Uttara Knitwears Ltd Uttara Knitting and Dyeing Ltd

South Panisail, Jirani Bazar, Gazipur
(23.98892N, 90.25913E)

07 June 2014

Structural Inspection Report

Item 1 – High column stresses in the columns to Building 2

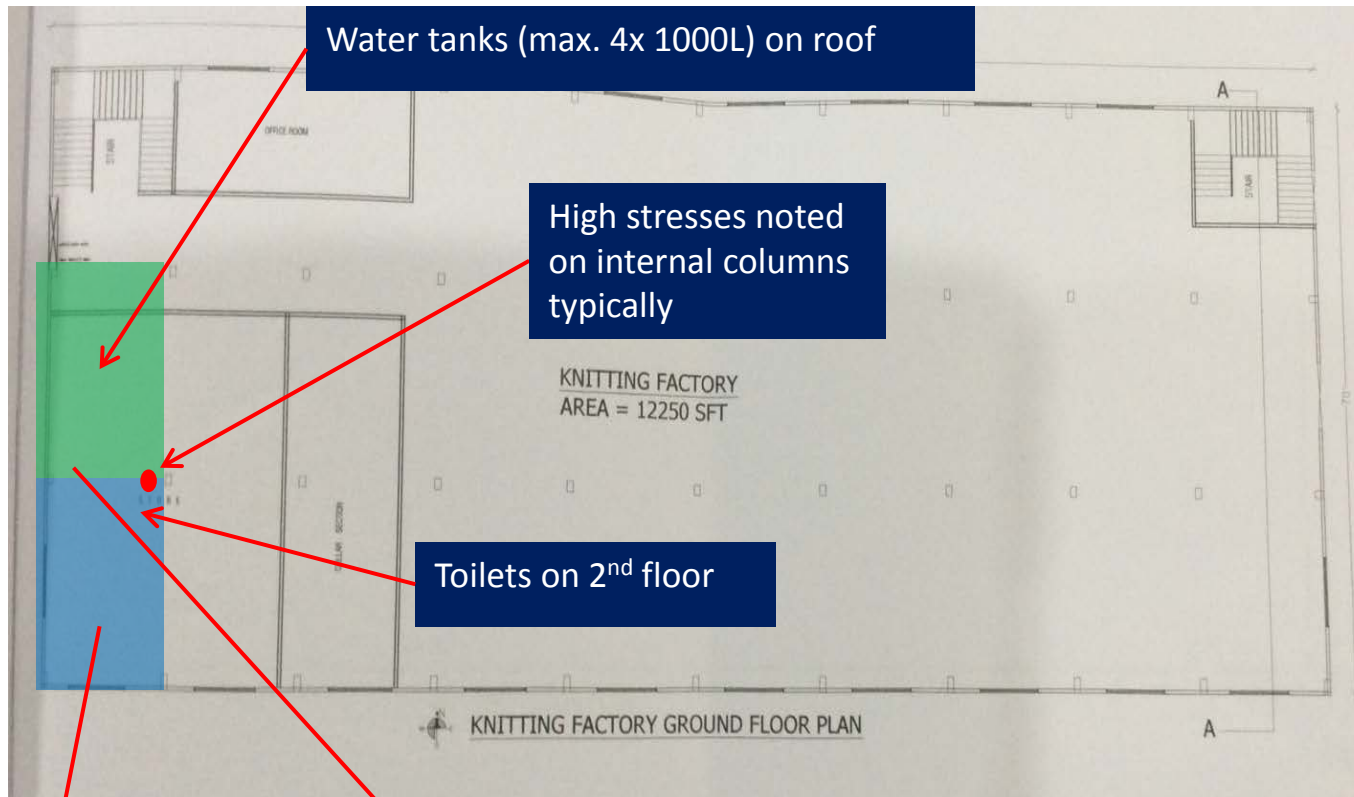
High Column stresses in the columns to Building 2

High Column stresses in **all columns in Building 2**.

- Maintain the current use of the floors and don't change use or increase occupation, either of which could increase loading.
- The Building Engineer is to review design, loads and column stresses in all columns in the Building 2.
- Verify insitu concrete strength either by taking 100mm diameter cores from 4 columns (minimum) or by using existing cylinder strength data for cores. Reinforcement quantities also to be confirmed.
- A Detailed Engineering Assessment of Building 2 is to be carried out to the scope attached.

- Complete the Detailed Engineering Assessment for Building 2.
- Produce and actively manage a loading plan for all floor plates within the factory giving consideration to floor capacity and column capacity.

Item 2 – Design check required for the structure supporting the water tanks in Building 2

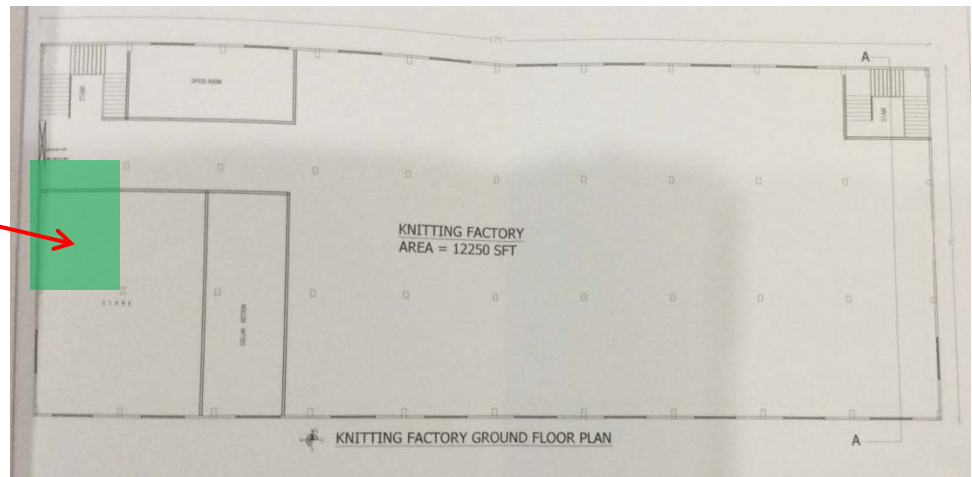
Design Check required for the structure supporting the water tanks in Building 2

Structure supporting 4x 1000L water tanks

Water tanks (max. 4x 1000L) on mezzanine at underside of roof

- The Building Engineer is to carry out a Design check to confirm the structural adequacy of the supporting structure as part of the Detailed Engineering Assessment.
- Produce and actively manage a loading plan for all floor plates within the factory giving consideration to floor capacity and column capacity.

Item 3 – Design check required for the loading from the toilet plinths in Building 2

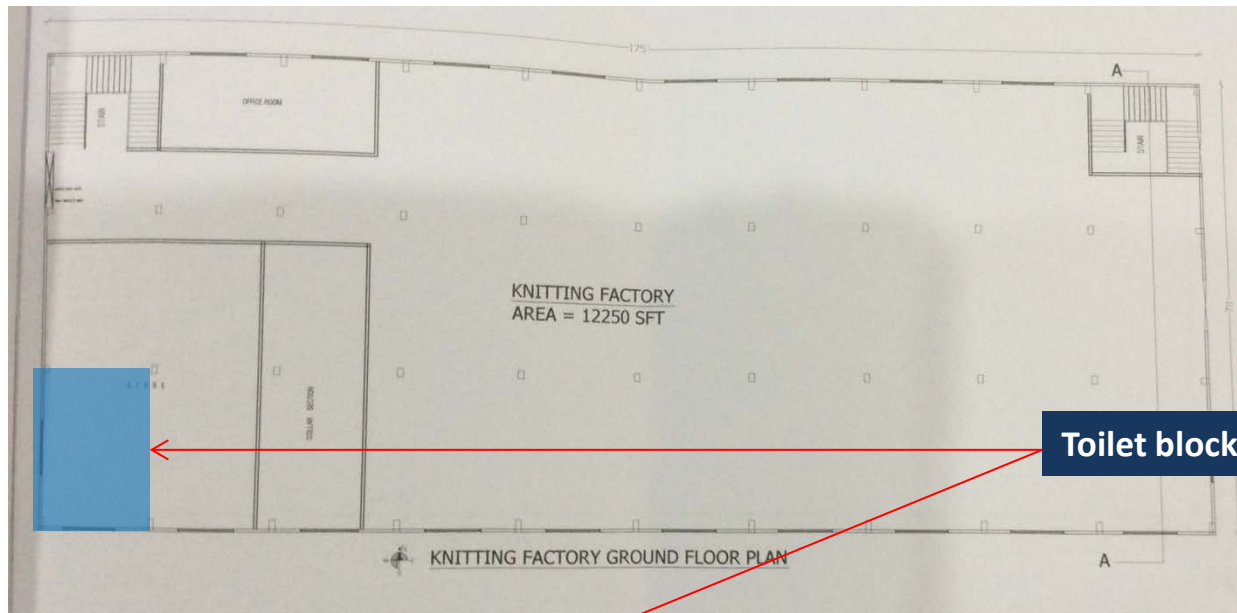
Design check required for the loading from the toilet plinths in Building 2.

Toilet block on 2nd floor

Plinth in toilet block

- The Building Engineer is to carry out a Design check to confirm the structural adequacy of the supporting floor structure as part of the Detailed Engineering Assessment.
- Produce and actively manage a loading plan for all floor plates within the factory giving consideration to floor capacity and column capacity.

Item 4 – Design check required for the structures supporting the water chiller and water tanks as noted

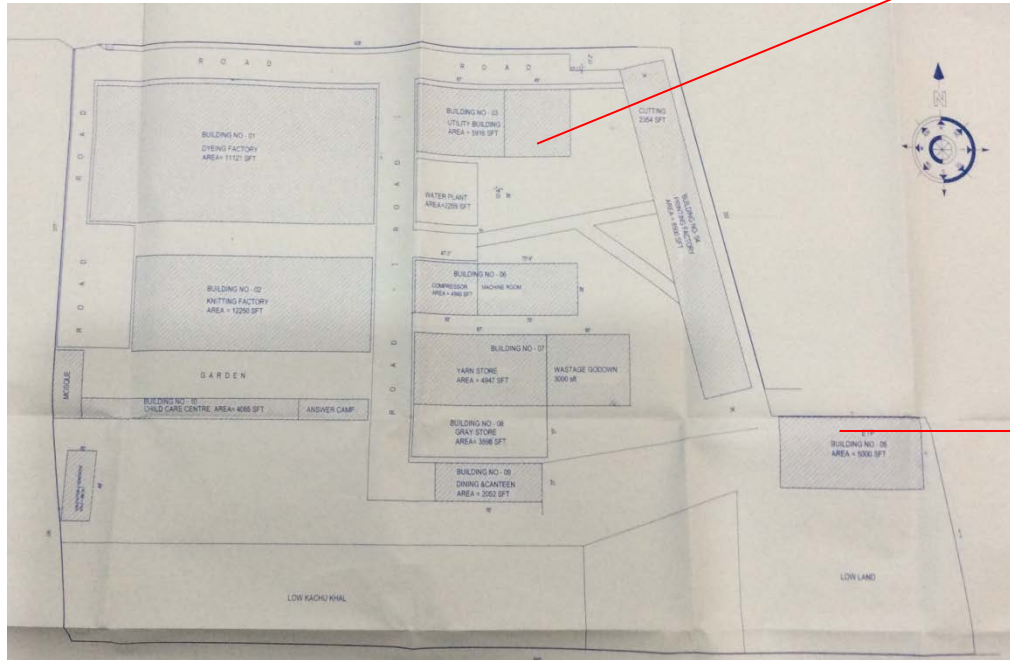
**Design check required for the structures
supporting the water chiller and water tanks
as noted.**

- The Building Engineer is to check the structural capacity of the floor and roof structures supporting the chiller and water tanks to transfer the loading to the columns.
- Produce and actively manage a loading plan for all floor plates within the building giving consideration to floor capacity and column capacity.
